PCI #COR010

Project: 220057 - Heart of the Valley WWTF 801 Thilmany Road Kaukauna, WI 54130

Potential Change Item #COR010

RFP 008 - Thickener and Filter Room Floor

SLUDGE HANDLING AND FILTRATION BUILDING COATING PLAN HEART OF THE VALLEY
METORPOLITAN SEWERAGE DISTRICT
WASTEWATER TREATMENT FACILITY
EFFLUENT FILTRATION IMPROVEMENTS

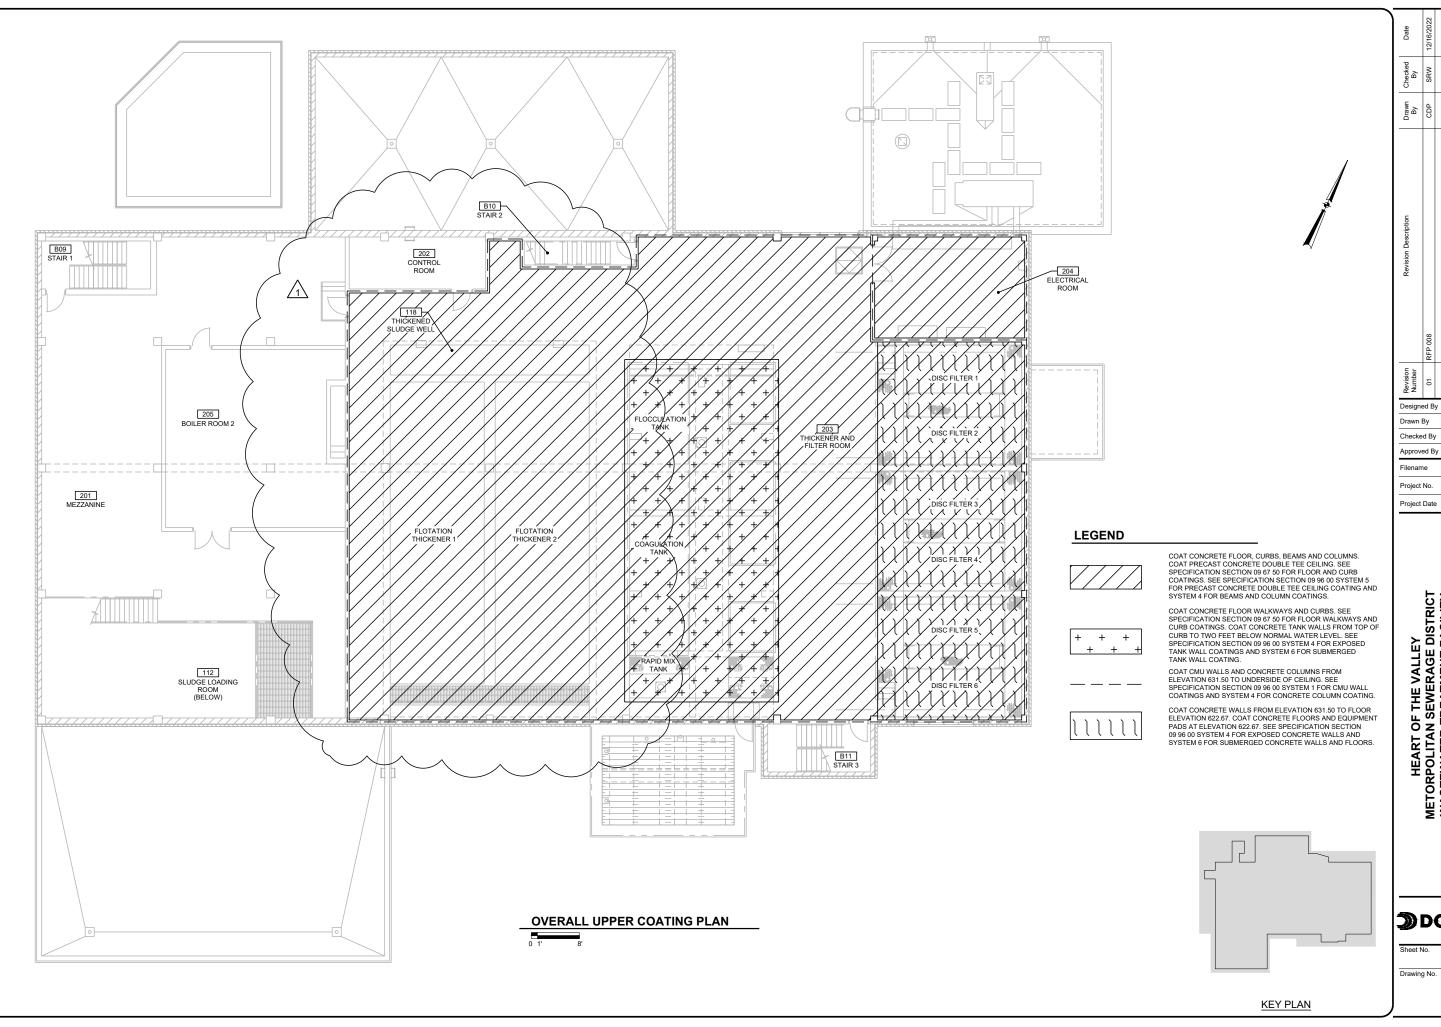
Apply high build epoxy flooring around Flotation Thickener 1 and 2 in the Sludge Handling and Filtration Building to match the new high build epoxy flooring being installed. Provide coating system to precast, beams, and columns.

This Request for Proposal (RFP) is being prepared to apply high-build epoxy flooring around Flotation Thickener 1 and 2 in the Sludge Handling and Filtration Building (Structure 060) to match the new high build epoxy flooring being installed in the Thickener and Filter Room. The high build epoxy application should be applied such that the entire area is consistent. Provide Coating System 5 to precast concrete double tee ceiling and Coating System 4 for beams and columns at Flotation Thickener 1 and 2. Provide Coating System 1 for CMU walls and Coating System 4 for concrete columns from Elevation 631.5 to underside of ceiling at Flotation Thickener 1 and 2. See attached Drawing 060-A-7.
